Case #H 92-38 Meeting Date March 23, 1992

Project Address 210 Don Gaspar District Core

PROPOSAL: New door, entry way on Water Street at restaurant entrance.

memo

FACING PROPOSED DOOR FROM
INTERIOR OF BUILDING, FACING NORTH

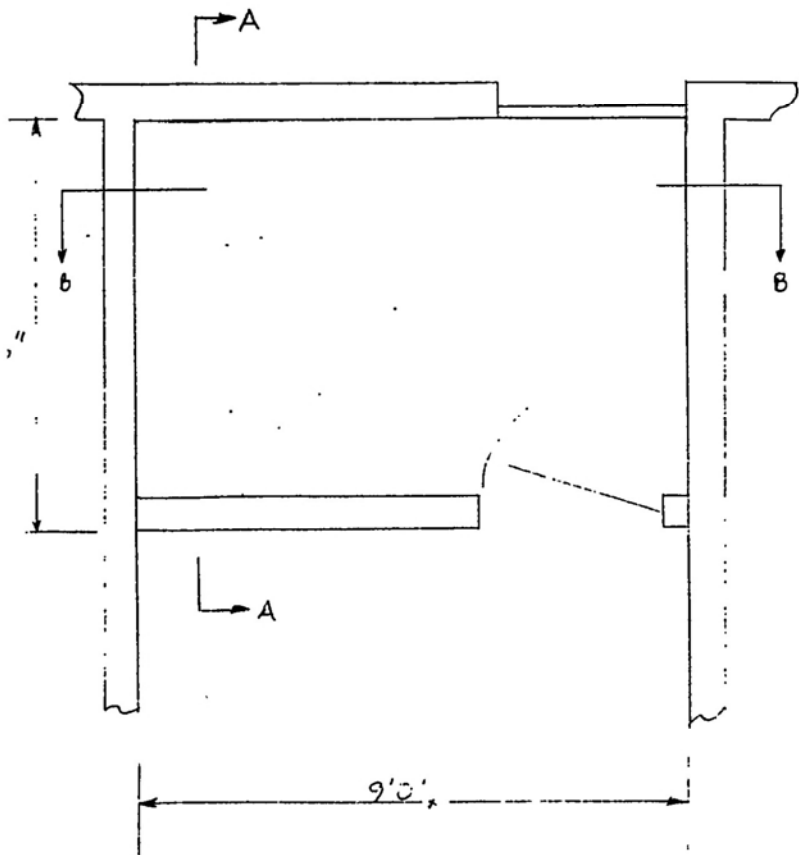
* subject doorway.

HUNTS & LINDSEY		REMARKS
<input checked="" type="checkbox"/>	HISTORIC DESIGN REVIEW	Condition of the fence & track the door's window be made to match the existing fence track
<input checked="" type="checkbox"/>	LANDSCAPE REVIEW	
<input checked="" type="checkbox"/>	ESCARPMENT ARCH. REVIEW	
<input checked="" type="checkbox"/>	APPROVAL	
<input type="checkbox"/>	CONDITIONAL APPROVAL	
<input type="checkbox"/>	REJECT	
NAME		DATE 3-23-92
WATER ST.		Paul [Signature]

PLAN
scale 1/2" = 1'0"

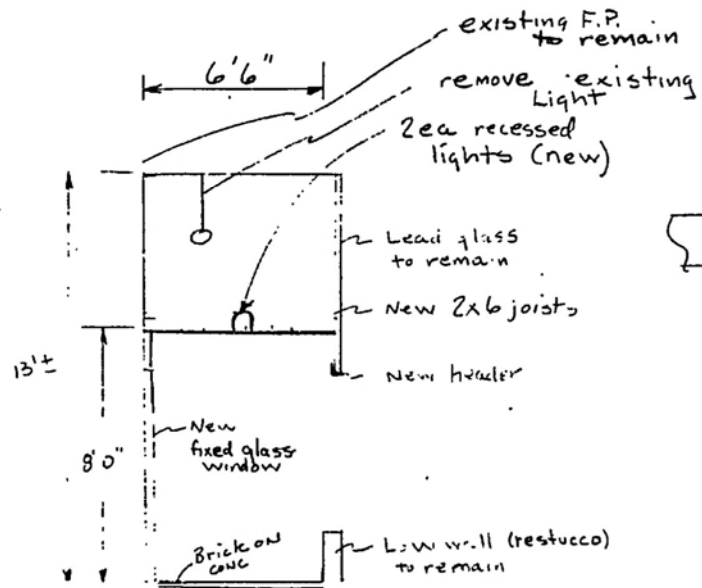
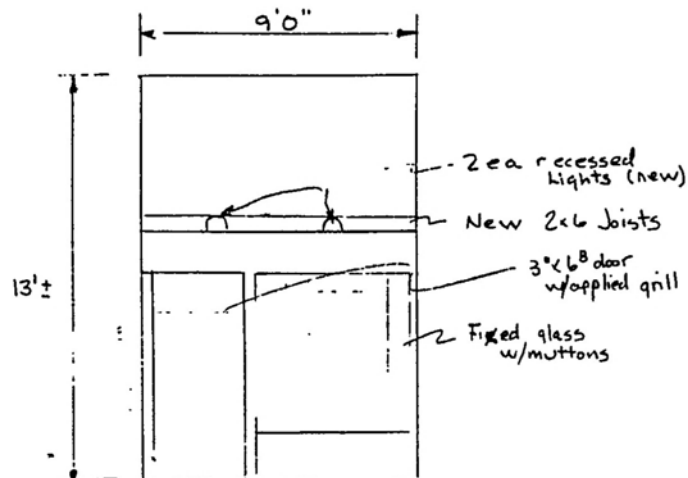
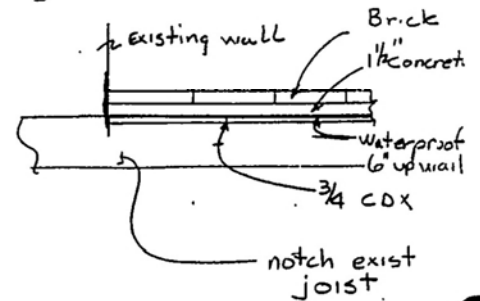
The enclosed proposal, which focuses on the West door/window bay on the buildings N. (Water St. elevation) facade, includes removing the existing door and window and recessing the entry way to 6 ft. The existing transom lights will be retained and a new header installed to support them. The new door and window will be divided lights and wood work will be painted white. In addition, the existing knee wall will be retained and be built out (into the recess) for use as a planter.

Since this work is occurring on a secondary facade, and is held back away from the primary corner of Don Gaspar and Water Street, it will not impact the historic status of the building. In addition, this area will continue to read as a void, as it currently does in its store front configuration. Staff recommends approval.
